Access Compliance Report

Public Rights-of-Way

(Curb Ramps)

Intersection ID: 10031809	Main Street: MILLENNIUM_AV	Cross Street: AUDUBON_PARK_DR	Location: E
ADA ID: BE5C7A832942	Ramp Type: Directional1	Initial Pass/Fail: Fail	Overall Compliance: No
Severity Score: 13.75			
Codes/Mitigation Info/Possible Solution		Field Measurements/Component Compliance

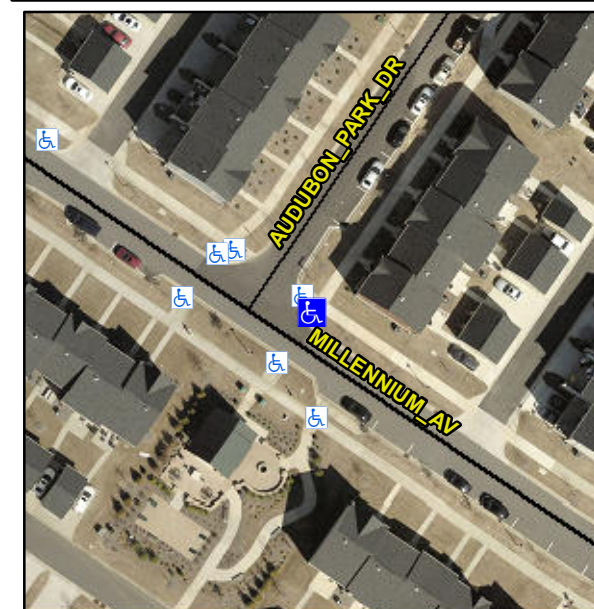
R304.2.2, R304.5.3

Compliance	Description	Data	Compliance	Description	Data
N/A	Ramp Length (in)	58.0	N/A	Grade Break?	N/A
Yes	Ramp Width (in)	70.0	N/A	Grade Break Slope (%)	0.0
No	Ramp Slope (%)	11.0	N/A	Grade Break XSlope (%)	0.0
No	Ramp XSlope (%)	3.3			
N/A	Flare Type LT	N/A	N/A	Flare Type RT	N/A
N/A	Flare Slope LT (%)	N/A	N/A	Flare Slope RT (%)	0.0
N/A	Flare Traversable LT?	N/A	N/A	Flare Traversable RT?	N/A
N/A	Landing Length (in)	0.0	N/A	DWS Provided?	N/A
N/A	Landing Width (in)	0.0	N/A	DWS Contrast?	N/A
N/A	Landing Slope (%)	0.0	N/A	DWS Length (in)	N/A
N/A	Landing X Slope (%)	0.0	N/A	DWS Full Width?	N/A
N/A	Landing Curb? (Y/N)	N/A	N/A	DWS Offset LT (in)	N/A
N/A	Shared Landing?	N/A	N/A	DWS Offset RT (in)	N/A
N/A	Gutter Ponding?	0.0	N/A	Gutter Slope (%)	N/A
N/A	Gutter Lip Ht (in)	0.0	N/A	Gutter X Slope (%)	N/A
N/A	Painted X Walk1?	No		Road Slope (%)	3.8
	X Walk 1 Direction	To SW		Road X Slope (%)	2.2
	X Walk 1 Width (in)	N/A		Clear Space?	N/A

X Walk 1 Slope (%)	3.8	N/A	Clear Space to XWalk (in)	N/A
	X Walk 1 X Slope (%)	2.2	N/A	Storm Grate/Utility Hazard?	N/A
N/A	Ramp inside XWalk1?	N/A		Storm Grate/Utility Type	
N/A	Any Obstructions?	N/A			N/A
	Obstruction Type		Yes	Surface Condition? (G/P)	Good
			N/A	Curb Slope (%)	9.3

Remove & Replace Entire Ramp.
